WEST PRINCETON PROJECT 12,16,20,24,100 W. PRINCETON ST.

SUMMARY

Staff recommends approval of the West Princeton Project minor subdivision request subject to the conditions in this staff report.

BOUNDARY SURVEY

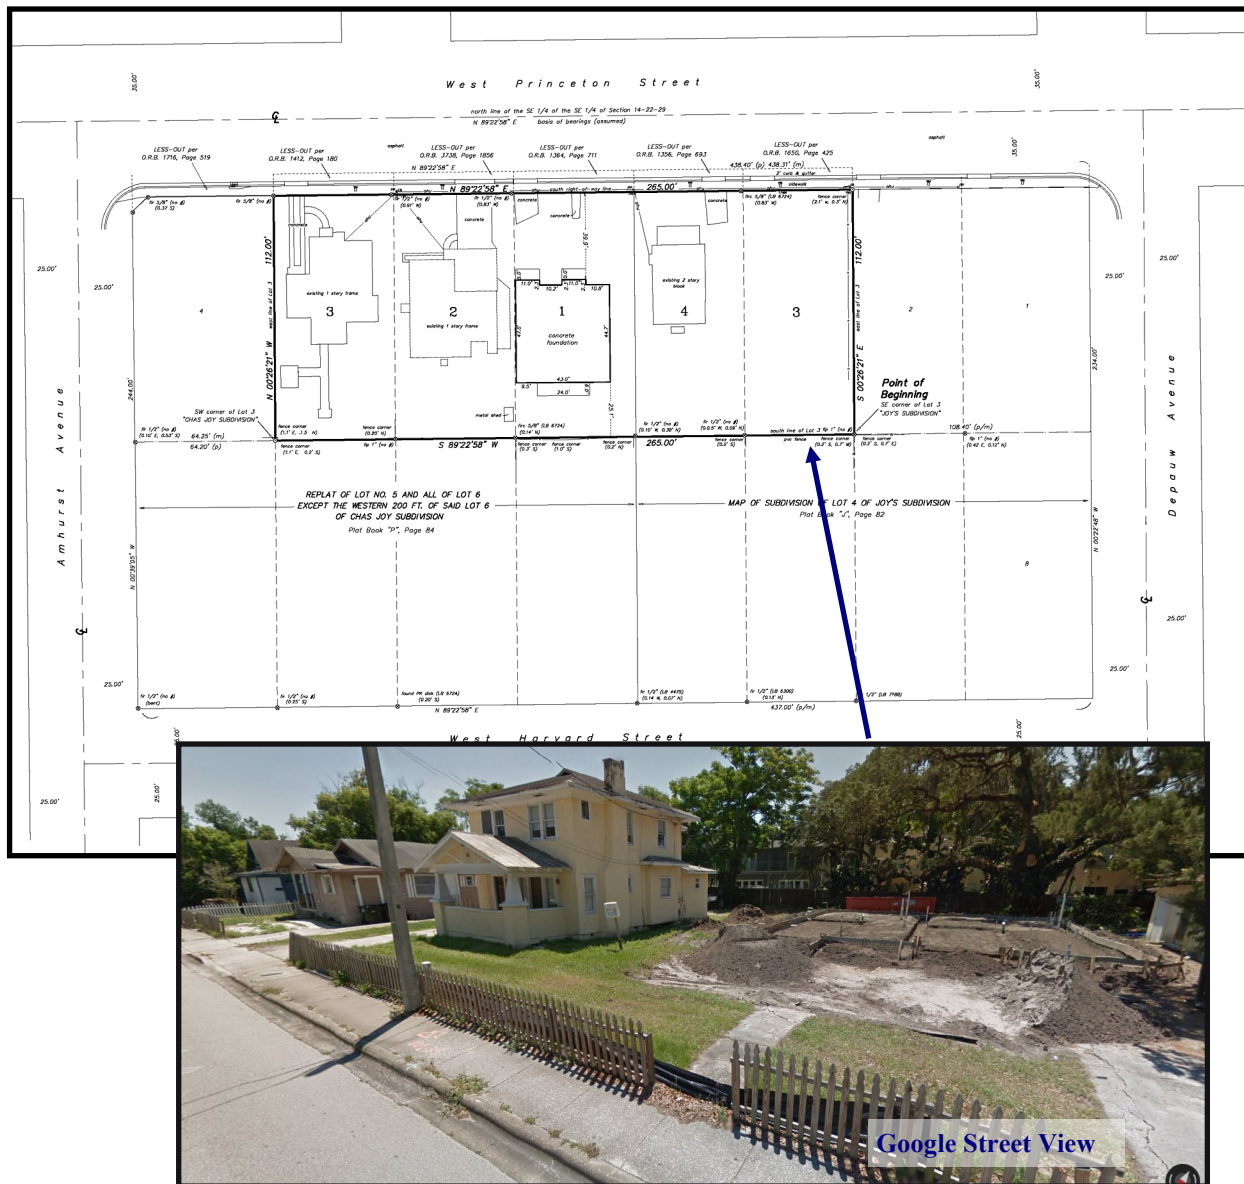
1. The plat you have submitted for the first time called West Princeton Project has not passed the review process for the following reasons:
 - a. 1. Sheets: (Surveys) The abbreviations TRB, Fip and grate inlet are missing in the Legend.

- b. 2. Sheet: (Boundary) The less out leader lines are missing on both ends of W Princeton Street.
 - c. 3. Sheet: (Boundary) The north adjoining lot numbers are missing. FAC 5J-17.052 7) a.

- d. 4. Sheet: (Plat) Add sufficient ties to the controlling lines of the previously recorded subdivisions. FS 177.091 (17)
 - e. 5. Sheet: (Plat) The referenced less out documents of W Princeton Street are missing in the notes.

- f. 6. Please change the Vicinity Map, Plat and Surveys to W Princeton Street and W Harvard Street.
 - g. 7. Sheet: (Topo) Trees are missing per Tree & Woodlands Survey Sub. App. Requirements page 5
